# Addendum/Addenda

No./N° 2
-------------

Project Description / Description de projet <b>M-20 Vertical and Horizontal Loading Frame</b>		
Solicitation No./ N° de sollicitation <b>17-22016</b>	Project No./N° de projet <b>M20 - 5313</b>	W.O. No./N° d'ordre de travail <b>A1-006215-01-02</b>
Departmental Representative / Représentant Ministériel  <b>Janik Leroux</b>	Date  <b>June 14, 2017</b>	
<b>Notice:</b> This addendum shall form part of the tender documents and all conditions shall apply and be read in conjunction with the original plans and specifications.		<b>Nota:</b> Cet addenda fait partie intégrale des dossiers d'appel d'offres; toutes les conditions énoncées doivent être lues et appliquées en conjonction avec les plans et les devis originaux.

**NRC BUILDING M20 /  
CNRC EDIFICE M20**

Drawing / Dessin  
**SSK-S03**  
**-01**

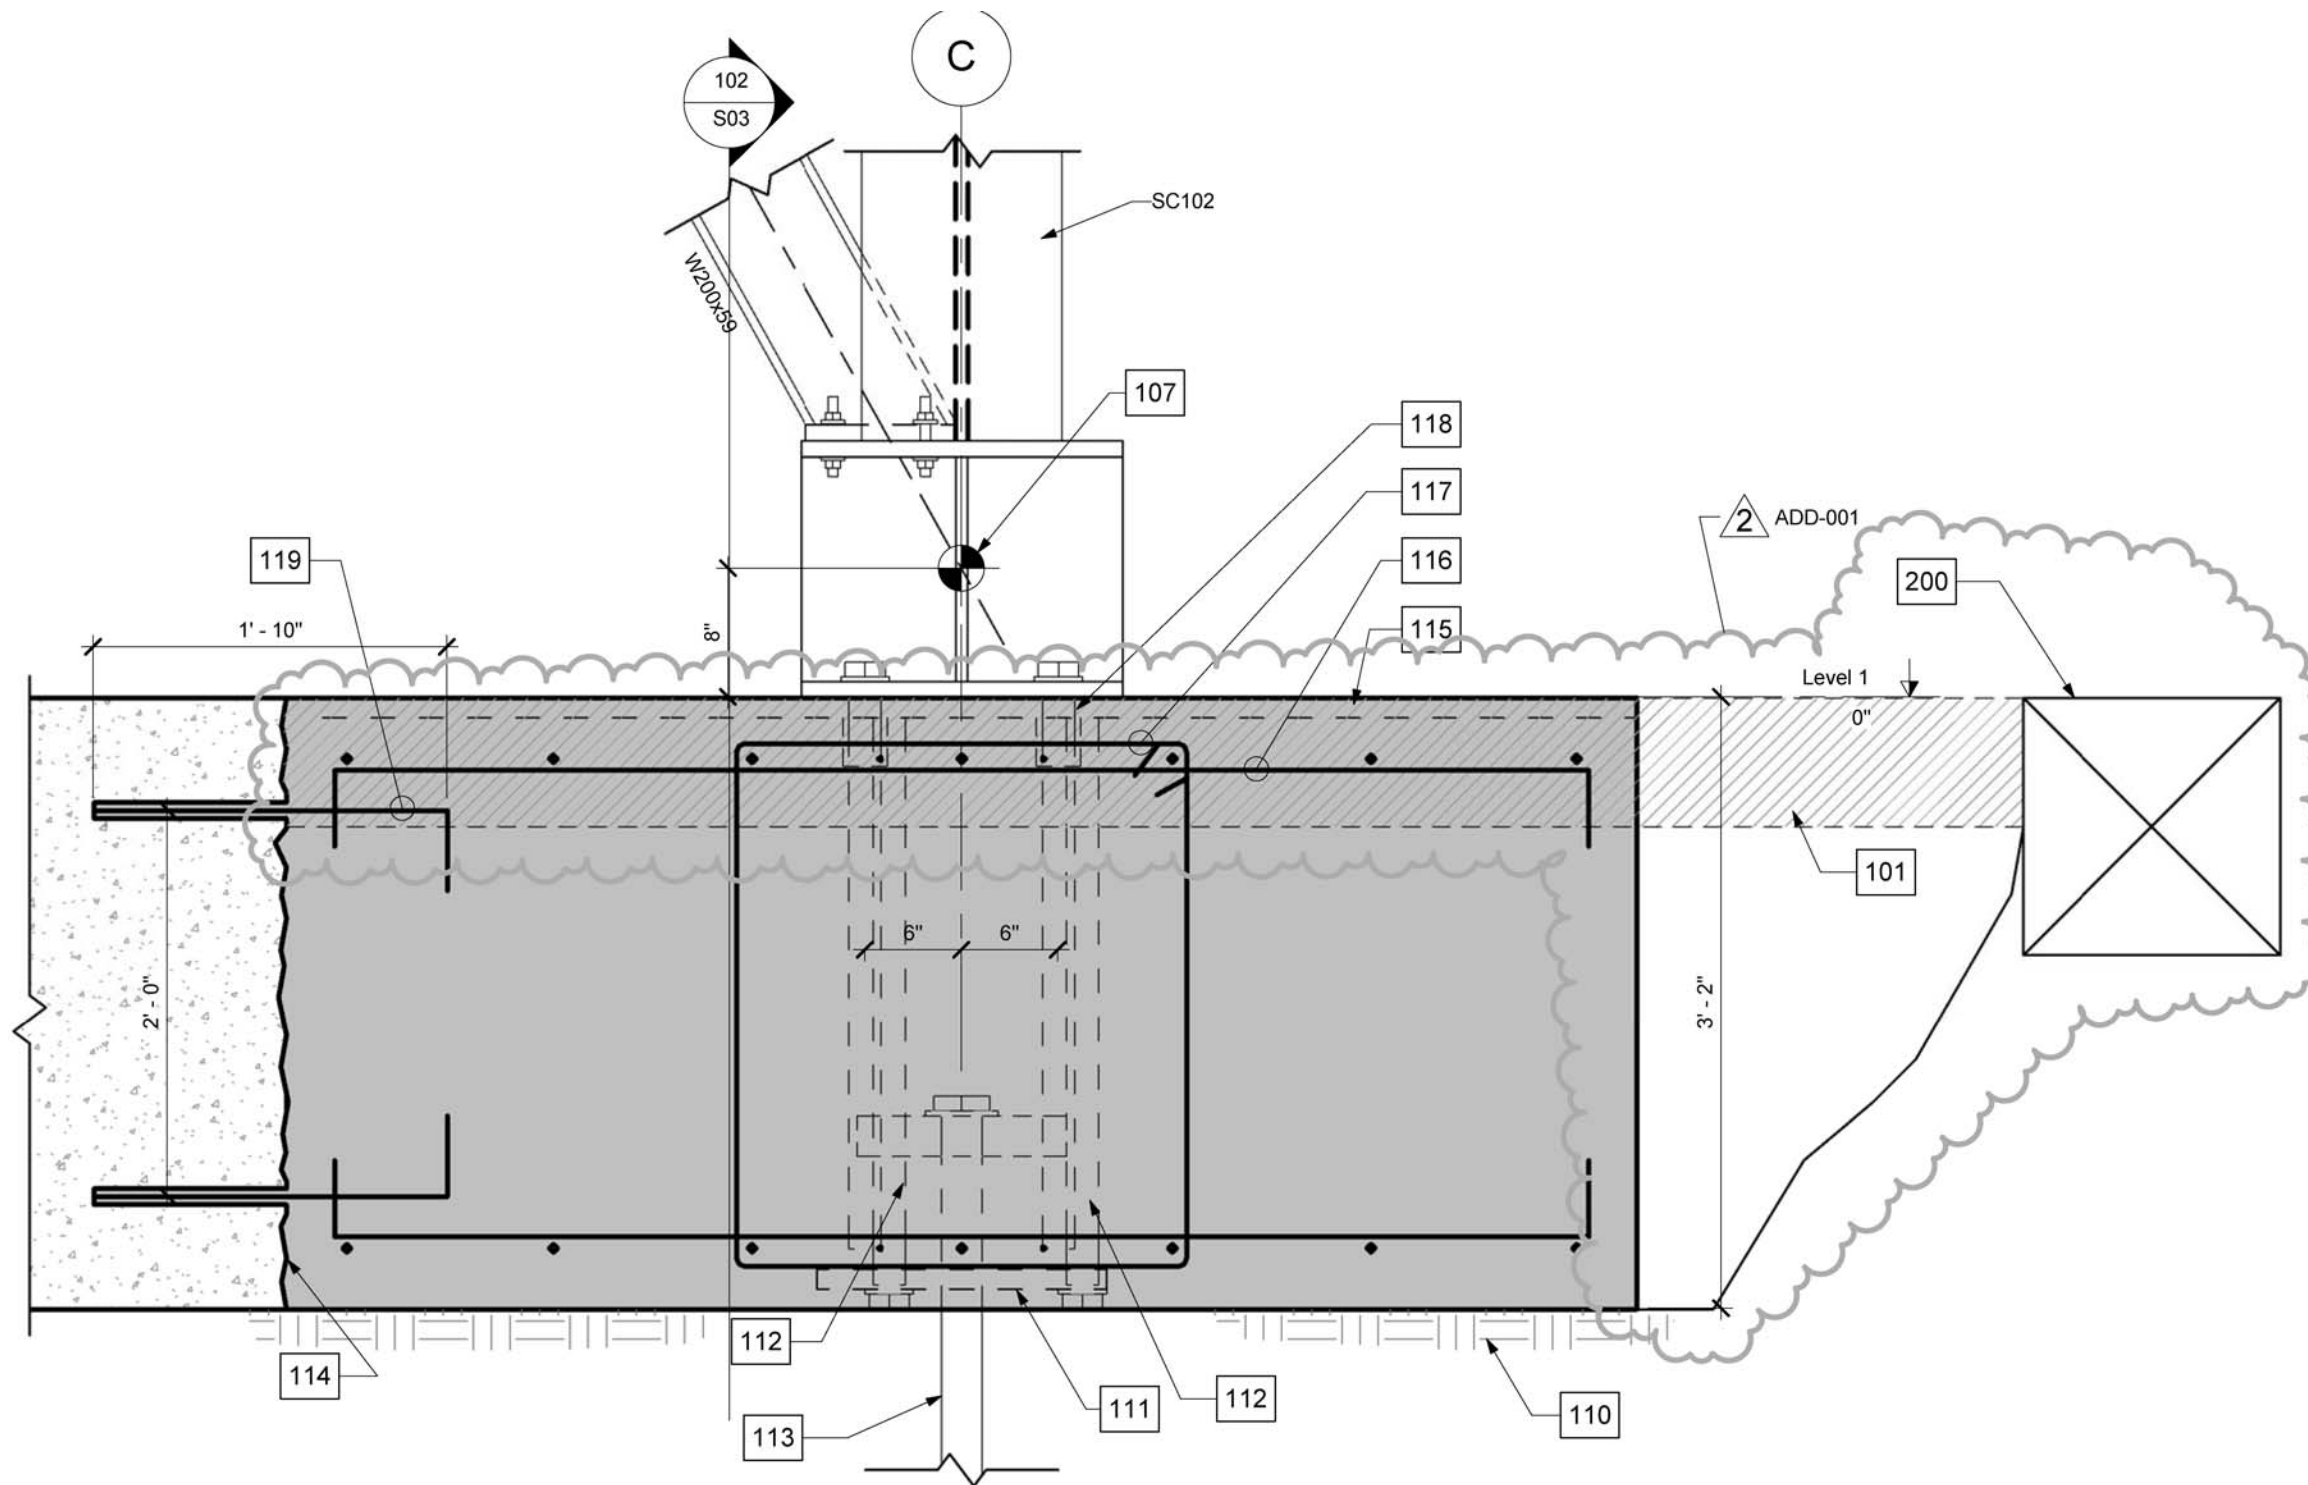
Refer to attached sketch SSK-S03-01 showing existing trench to remain adjacent to new strong floor.

100	EXISTING CONCRETE STRONG FLOOR / PLANCHER ROBUSTE ET EXISTANT EN BÉTON.
101	DEMOLISH AND REINSTATE EXISTING CONCRETE SLAB DOWN TO BEDROCK (±3'-2" DEEP) / DÉMOLIR ET REINTÉGRER LA DALLE EXISTANTE EN BÉTON ET CE, EN DESCENDANT JUSQU'À L'ASSISE ROCHEUSE (±3'-2" DE PROFONDEUR).
102	PROVIDE STIFFENER PLATES AS DE MONTAGE
200	EXISTING TRENCH TO REMAIN. / CANIVEAU EXISTANT À DEMEURER
